**Commonwealth Edison**  
 One First National Plaza, Chicago, Illinois  
 Address Reply to: Post Office Box 767  
 Chicago, Illinois 60690

Subject: Byron Station Units 1 and 2  
 Braidwood Station Units 1 and 2  
 Turbine Missile Study  
 NRC Docket Nos. 50-454, 50-455,  
50-456, and 50-457

This is to provide advance copies of revised FSAR information regarding protection against possible turbine missiles at Byron and Braidwood stations. NRC review of this information should close Outstanding Item 2 of the Byron SER.

CORRECTIONS TO FAULT TREE

FIGURE C.4-1: TURBINE MISSILE FAULT TREE

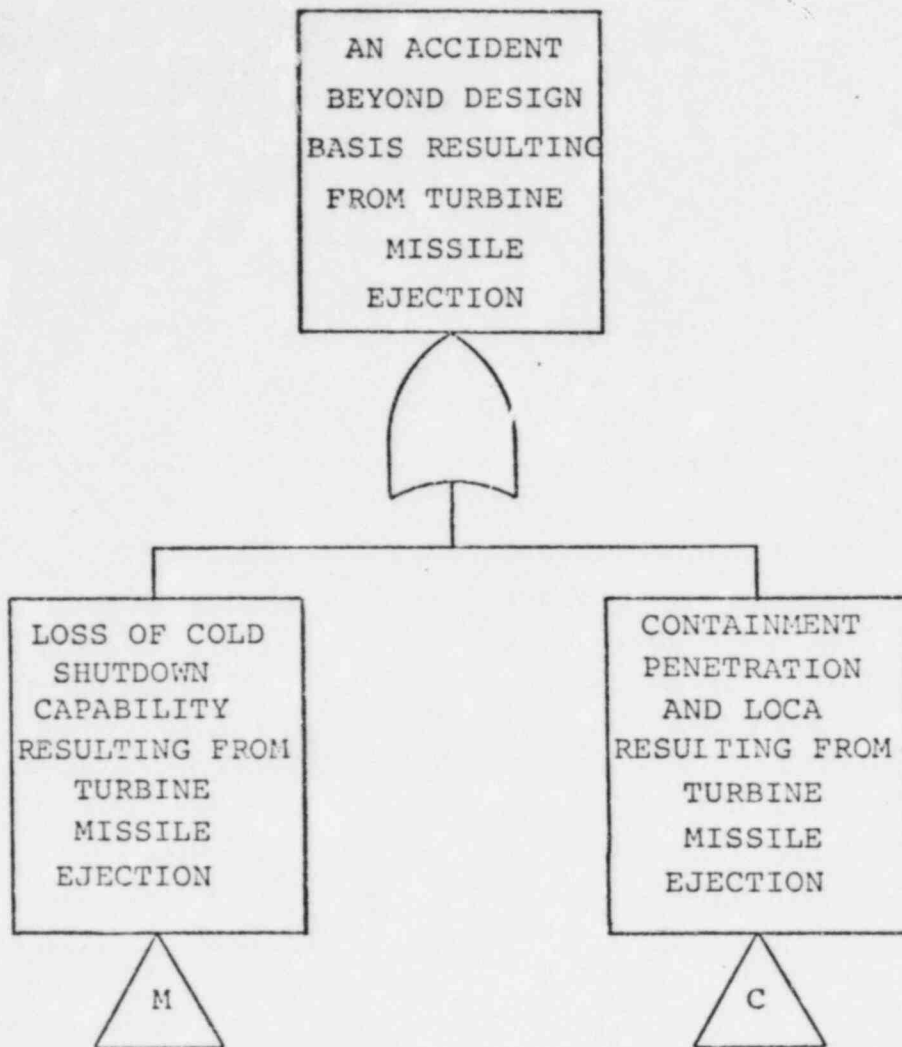
<u>Figure Number</u>	<u>Location of Correction</u>	<u>Correction</u>
C.4-1	All event blocks	Description expanded
C.4-2	Top event block in fault tree branch	Description expanded
	Upper center of page; circular event symbol	"Turbine trip" changed to "Missile ejection after turbine failure".
C.4-3	Top event block in fault tree branch	Description expanded
	Upper center of page; circular event symbol	"Turbine trip" changed to "Missile ejection after turbine failure".
C.4-4	Below OR gate at top of page; event block right-of-center	"Loss of radiological control" changed to "Loss of reactivity control"
C.4-6	Middle of page; left-of-center	Area designation 11.3A-1 changed to 11.3D-1
C.4-8	Bottom right hand corner of page	Second area designation from right side changed from 11.3-0 to 11.2-0
C.4-10	Bottom center of page	Fifth area designation from right side changed from 11.2-0 to 11.3-0
C.4-12	Upper right of center; below event block which reads "Failure of RHR HX".	Area designation 11.3F-1 changed to 11.3E-1.

FIGURE C.4-14: LOSS OF BORIC ACID TRANSFER PUMP CONTROL OR POWER

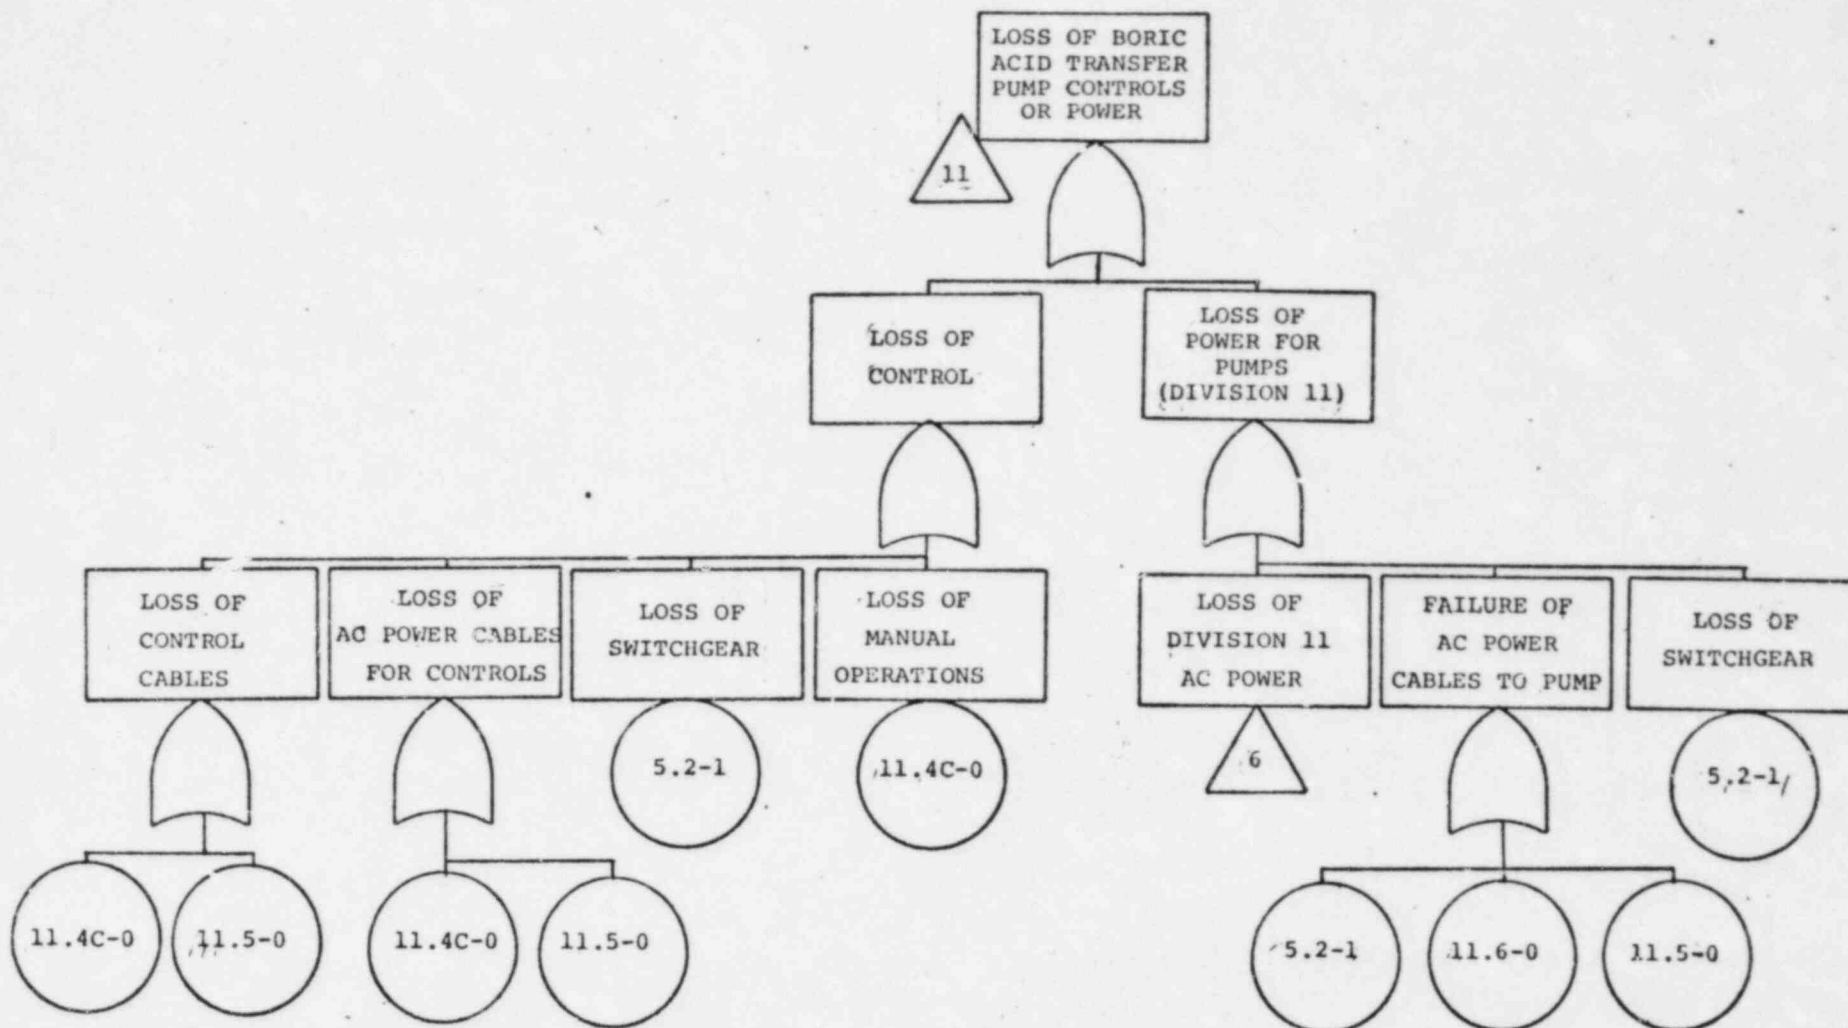
Triangle-shaped symbol at lower left corner of top event block.	Previously blank; now contains the number "9".
C.4-14	Below top event block in fault tree branch	AND gate changed to OR gate
